WORKSHOP
110 SHERIDAN STREET

TO: Chair Sheridan and Members of the Historic Preservation Board
FROM: Deb Andrews, Historic Preservation Program Manager
DATE: December 28, 2018
RE: January 2, 2018 **WORKSHOP – Preliminary Review of Proposed Two-Family Residential Construction**

Subject: R-6 Small Infill Design Review – 110 Sheridan Street

Burns-Leavitt Residence
110 Sheridan Street
Portland, ME 04101

Street Context

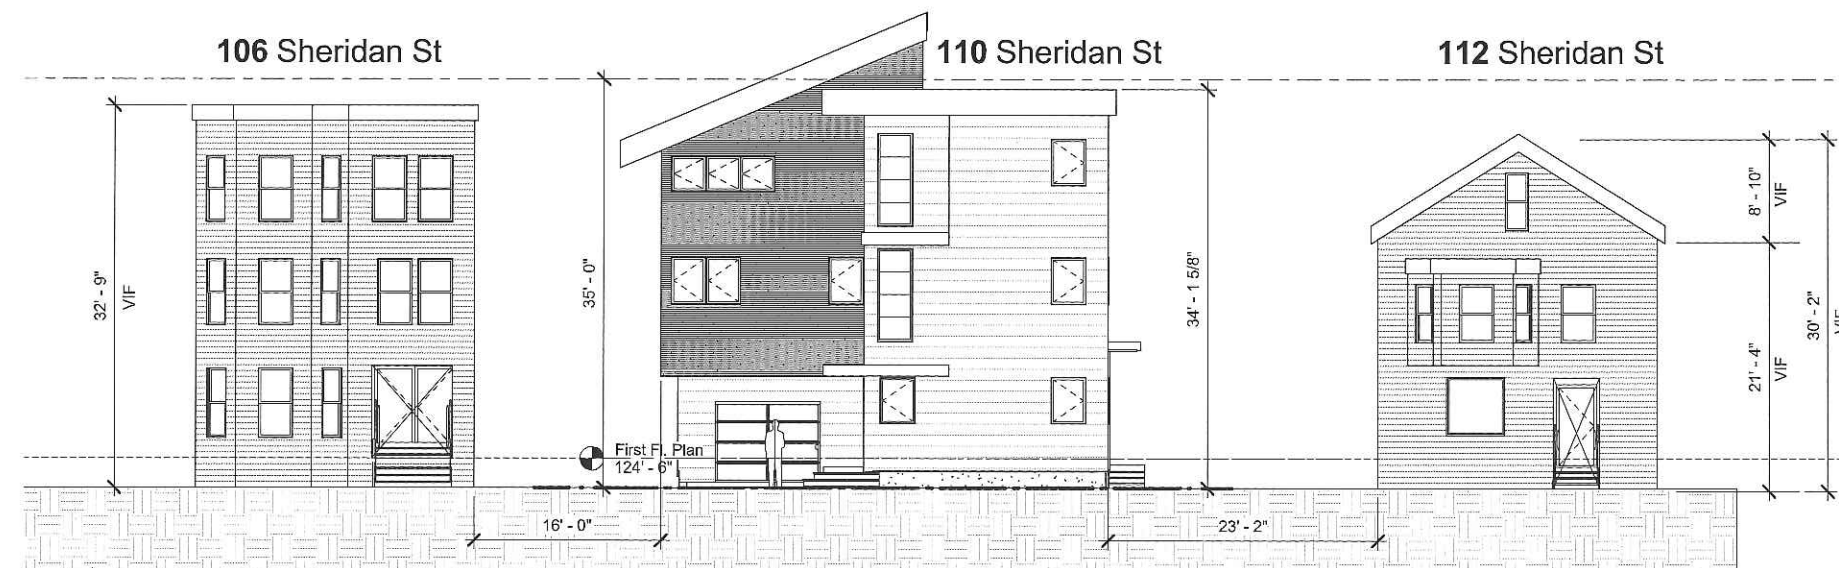
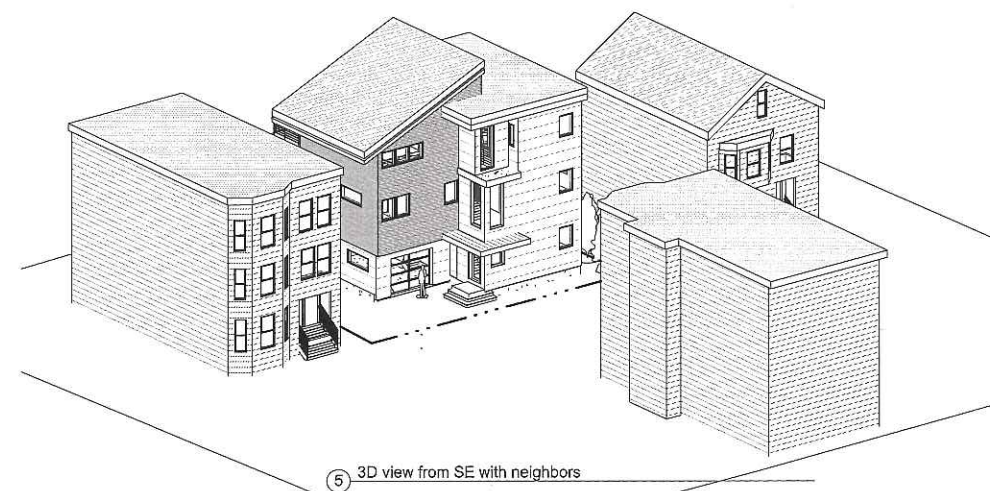
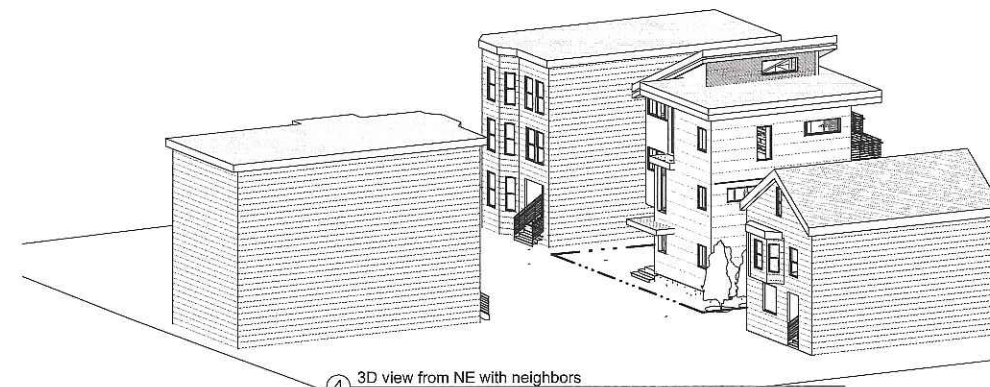
- *A-3 Relationship to the Street:* The building placement of the principal mass is slightly setback from the street which is not consistent with the spacing of the residential fabric – front façade right at the street, often with a side-facing entry. The driveway/building placement varies on this street – the project follows the general pattern of building with side drive. **The Board is asked to determine whether the front setback could be considered compatible with this standard.** Recessing the secondary mass is consider appropriate here to mitigate the impacts of the garage and building scale – staff support that relationship to the street.

Proposed Elevations Wdw & Dr Schedules

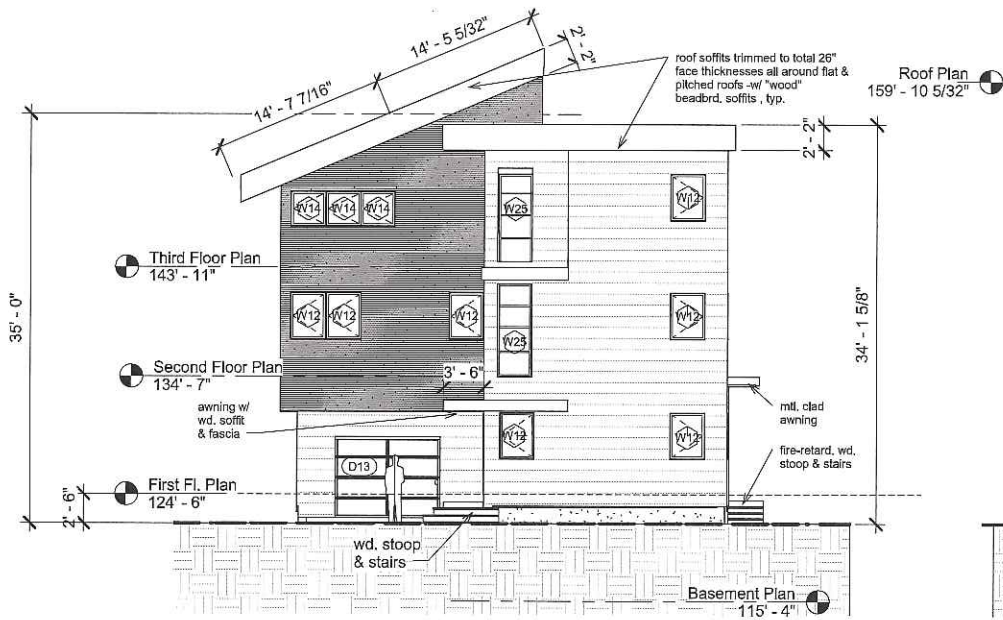
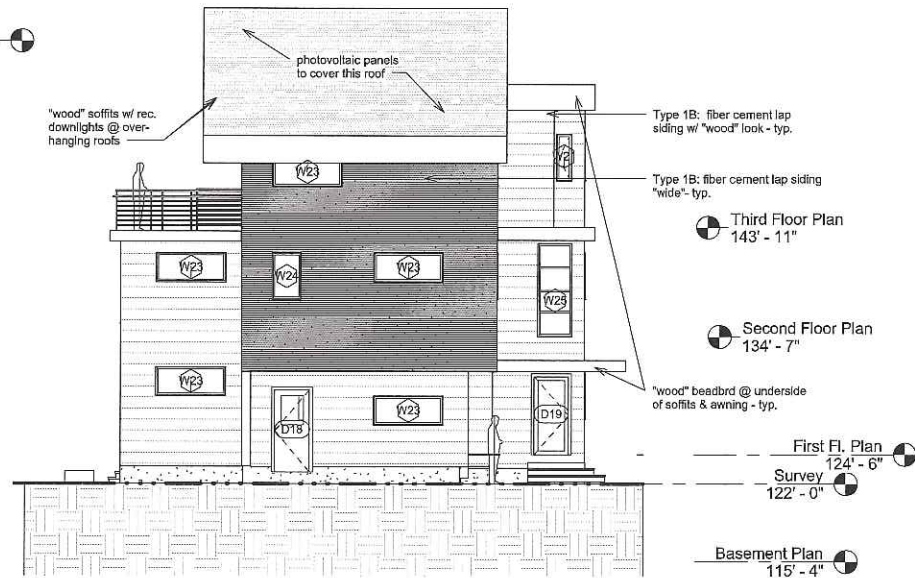
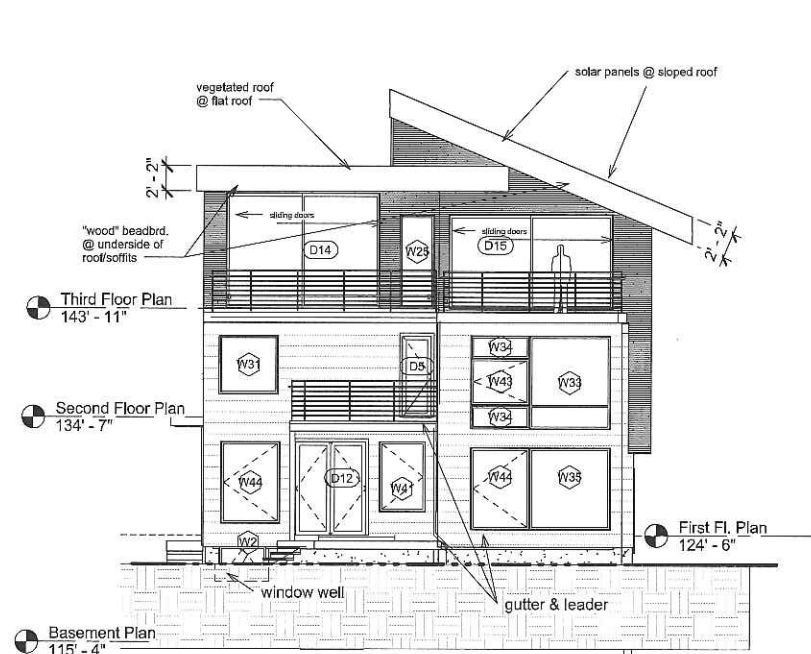
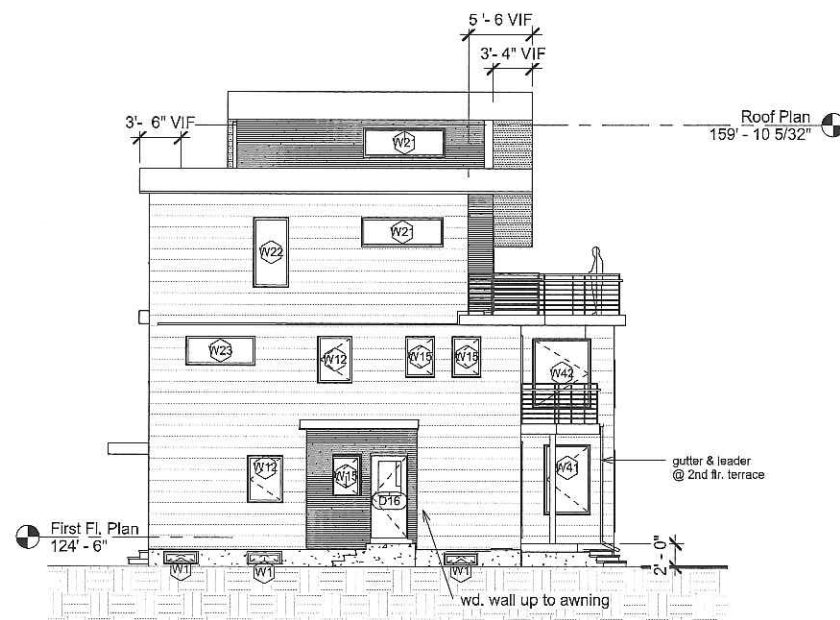
- **Correct the material labels**
- **Staff request Board feedback on building placement, window/solid proportions, and the subsidiary roof form.**

- *A-2 Composition of Principal Facades:* The composition of the street-facing facade follows the vertical proportion and two-bay composition frequently found in the context in both the single and multi-family buildings. Instead of a bay window, traditionally found on triple-decker buildings, the project uses elongated windows, a recess, and overhangs to provide articulation to the front façade. **The windows are not the same size/proportion as found in the context – staff asks the board to weigh in on whether this could be considered to be compatible though different from the predominant character.**

- **B-2 Roof Forms:** Two roof forms are used while the traditional context predominantly has simple roof forms. Flat roofs are found in the context on multi-family buildings and are considered compatible. The monopitch roof is the more contemporary form and not readily found within this streetscape.

- **B-3 Main Roofs and Subsidiary Roofs:** The flat roof form should be the dominant roof form but staff question whether the monopitch roof is sufficiently subsidiary. The two roof forms are used with equal hierarchy in height and weight of cornice treatment.

- **B-4 Roof Pitch:** The secondary roof is monopitch and asymmetrical with a pitch of less than 7:12. The primary mass uses a flat roof consistent with similar building types and forms found on the street.

- *F-2 Window Types:* More than two window types and sizes are used on the street-facing façades – a third type is added for the kitchen use. The façade closest to the street, however, has only two window types according to the standard.
